CITY OF PORTLAND, MAINE

Project Name:	Suburban Propane	Project ID:	2016-047
Address:	636 Riverside Street	CBL:	322-A-3
Applicant:	Thompson's Point Development Co.	Planner:	Nell Donaldson

PLANNING BOARD REPORT PORTLAND, MAINE

Suburban Propane, 636 Riverside Street
Level III Subdivision and Site Plan Review
2016-047
Suburban Propane

Figure 5: Preliminary site plan

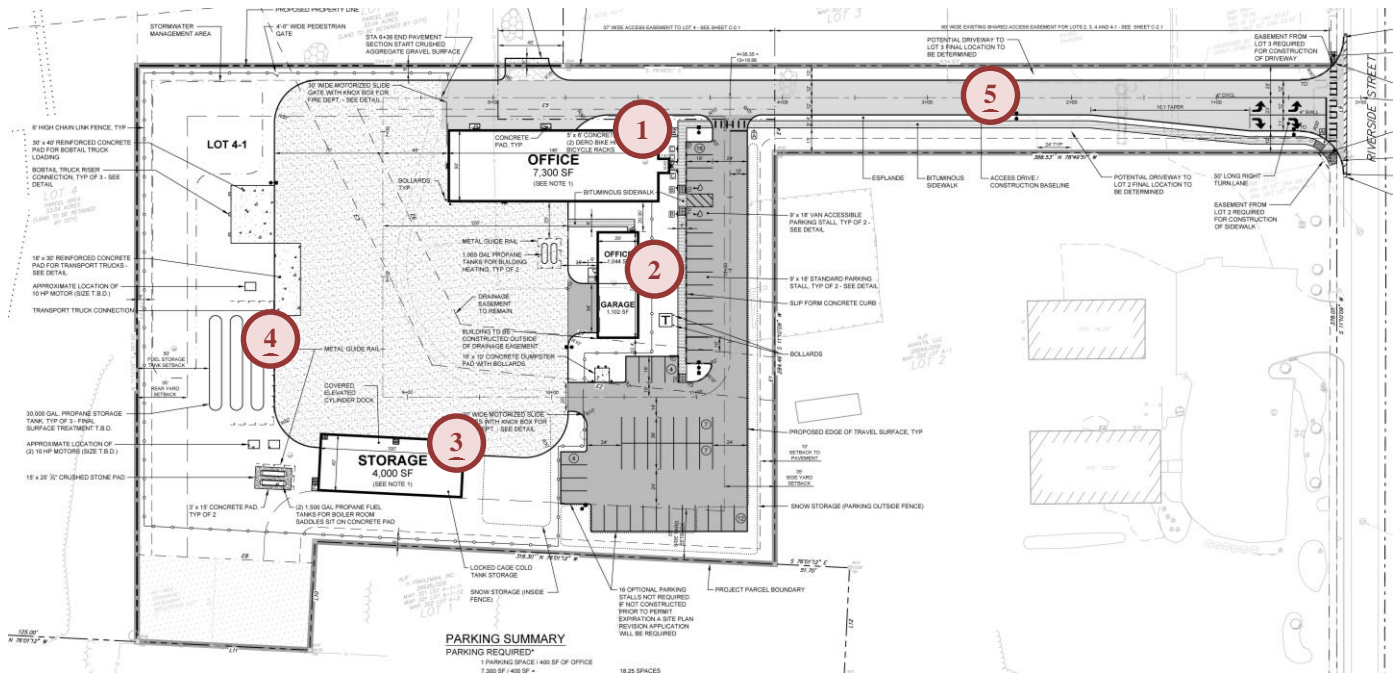
The plans include a new 24' access drive from Riverside Street. The final plans show two "potential" points of access from this drive to the adjacent lots (Lot 2 and Lot 3). These access points are a product of the original Riverside Subdivision plat. Pursuant to the development of this subdivision plat, the City of Portland granted a shared access driveway easement to Lot 2 (Ananta LLC) and Lot 3 (Addison Capital LLC "for the purpose of and conveying the right to perpetually enter at any and all times" over the access to Lot 4 from Riverside Street (*Attachment D*). Subsequently, the parties developed a Shared Access Driveway Maintenance Agreement, which stipulates that, when Lot 4 is developed, the owner of Lot 4 is to be responsible for constructing the shared access driveway, that the owner Lot 3 is entitled to access their lot via the driveway by providing written notice to the owners of Lots 2 and 4, and lastly, that the owners of Lot 4 will share maintenance of the shared driveway "with Lot 2 and/or Lot 3 in a reasonable proportionate share reflecting the length of the shared access driveway used by each lot and the approximate number of trips made by vehicles to and from each lot" (*Attachment D*). The applicant has acknowledged that the final location of these access points will be resolved pending future discussions with the adjacent property owners. Mr. Errico writes,

The plan notes approximate driveway locations for Lots 2 and 3. I find the currently depicted locations to be acceptable. Any changes to the locations shall be reviewed and approved by the City.

Division 20 of the land use ordinance establishes a parking requirement of 1/400 SF for office spaces and 1/1,000 SF for industrial buildings not catering to retail trade and with floor area over 3,000 SF. Based on these ratios, 24 parking spaces are required. The applicant’s final plans show 50 spaces in a paved parking lot to serve the 30-34 existing full time employees and 14 additional employees that might be housed at the site in the future. The applicant has noted in their final submittal that they may elect not to build these spaces. Mr. Errico has requested additional clarity on this point, writing,

The plans should either illustrate parking spaces intended for construction or they shall be removed them from the plans.

3. The applicant shall provide a revised plan set which:
 - depicts the final location of driveway access points to Lots 2 and 3; and
 - depicts only such parking as is intended for construction under the current application. The Planning Authority may review and approve administratively an increased parking area, as needed, within three years from the Planning Board's decision.

SHEET TITLE: **SITE LAYOUT PLAN**

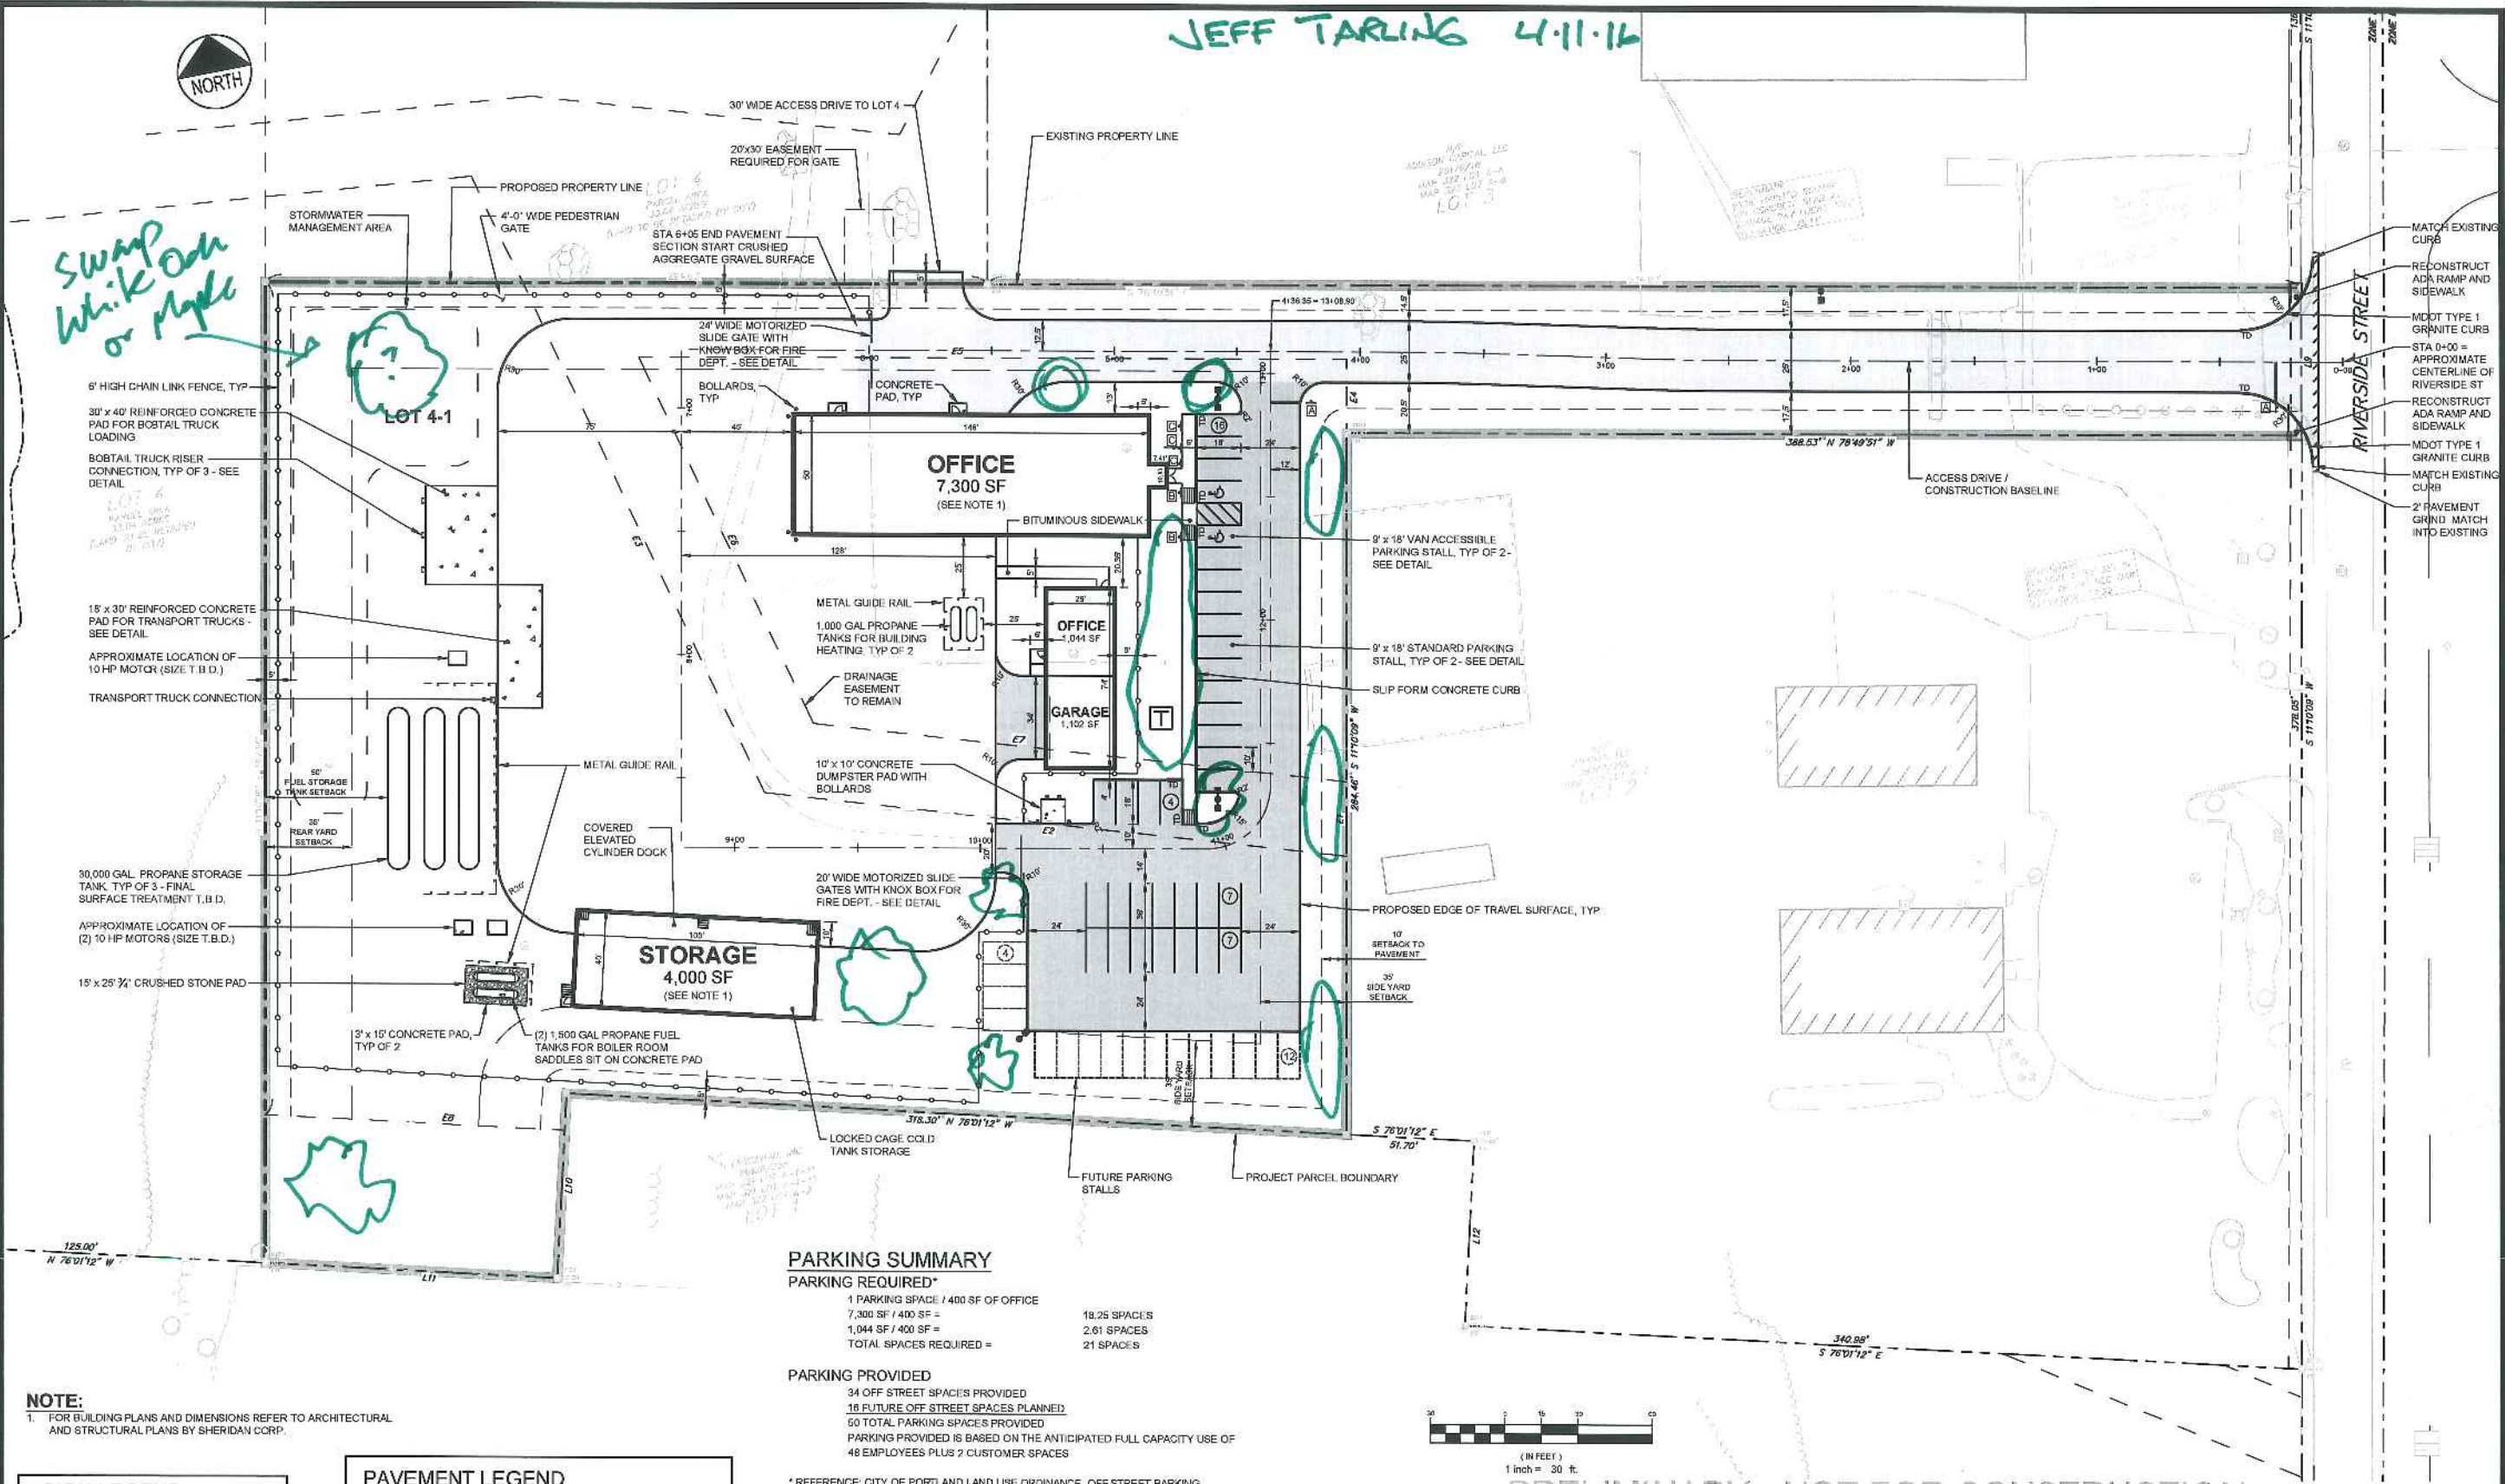
The proposed 636 Riverside Street project would benefit from a landscape / tree planting plan. The landscape plan should address any new parking areas, commercial property to city right of way interface, this would be the view to the site and landscape treatment to improve circulation. The landscape improvements could be incremental to the proposed site work vs the entire site.
